QUALITY ASSURANCE -- NON-CONFORMANCE REPORT

Report No: NCR-000559

Reference Description: Base Metal Repairs without Engineer's Approval, CB16

Job Name: SAS Superstructure

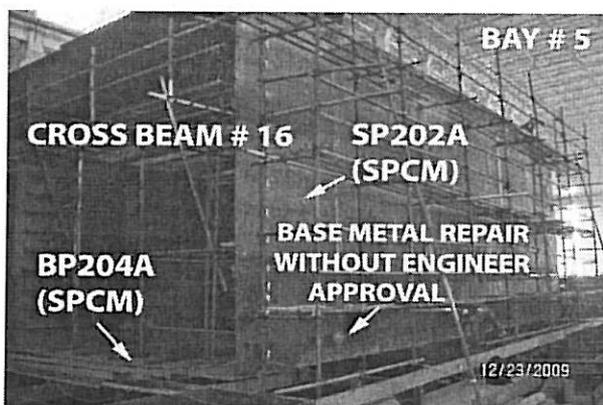
During a random visual inspection of the Orthotropic Box Girder (OBG) Crossbeam CB16, the Caltrans Quality Assurance (QA) Inspector observed ZPMC personnel performing Seismic Performance Critical Member (SPCM) base metal repairs on the Side Panel (SP) of Crossbeam CB16 without the Engineer's approval.

-The Bottom Panel (BP) was identified as: BP204A

-The SP was identified as: SP202A

-The weld number between the SP and BP is identified as: CB202A-016-005

-The WPS used was WPS-345-SMAW-3G (3F)-Repair.

Draft of welding discontinuity:

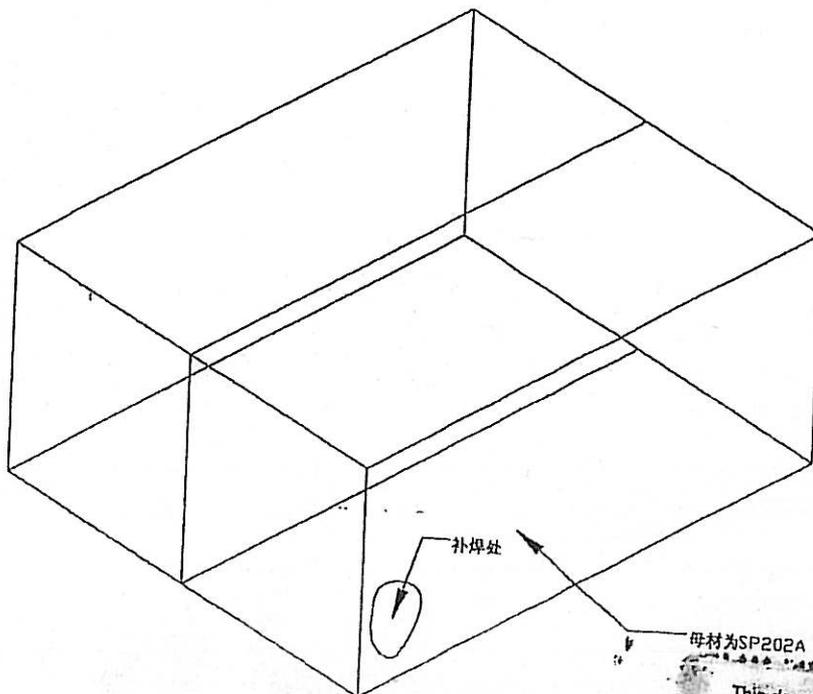
刘斌施工队制作的CB16横梁, 在临时构件割除后伤到了母材, 并且母材为FCM, 要进行补焊, 母材的编号为: SP202A.
 CB16 fabricated by work team: Liu Bin ,the base metal was gouged after removed temporary attachment and needed to build up, part No.:SP202A.

1. 碳刨时, 操作工操作失误, 吊耳拆除后, 母材损伤;
1. A gouging operated error and base metal was gouged after removed lifting.

1. QC和CWI在整个修补过程中都应在场并指导以确保返修按照处理意见以及AWS D1.5要求进行;
 2. 按照焊接返修工艺规程(WPS)打磨缺陷区域至光滑;
 3. 准备一个正确的接头形式, 具体参见返修的WPS;
 4. 在NDT检测前口头通知QA。对返修区域作100%MT和100%VT检查;
 5. 如果仍发现有缺陷, 通过打磨的方法去除所有缺陷以确认缺陷完全被清除, 并重复第四步以确认缺陷完全被清除;

6. 将杂物以及MT检测遗留的残留物清理干净;
 7. 根据批准的焊接返修工艺规程(WPS)进行预热及焊接;
 8. 将焊接区域打磨至与母材平齐;
 9. 在NDT检测前口头通知QA。对返修区域作100%MT和100%VT检查。
1. QC and CWI should be present to witness the repair, direct and supervise all repair operations during this repair to ensure the repair is per the disposition requirements, and the AWS D1.5 code requirements.

2. Grind the repair area to a smooth finish according to the approved repair WPS.
 3. Prepare the joint according to the approved WPS.
 4. Notify QA verbally prior to NDT. Perform 100%MT and 100%VT of the repair area.

5. Remove all defects by grinding to ensure all defects are completely removed if defects still exist, and repeat "step 4" to assure complete removal of all defects if necessary.

6. Clean the repair area of all loose debris including MT powder.
 7. Preheat and weld according to the approved WPS.
 8. Grind the weld flush with base metal after welding.

9. Notify QA verbally prior NDT. Perform 100%MT and 100%VT of the repair area.
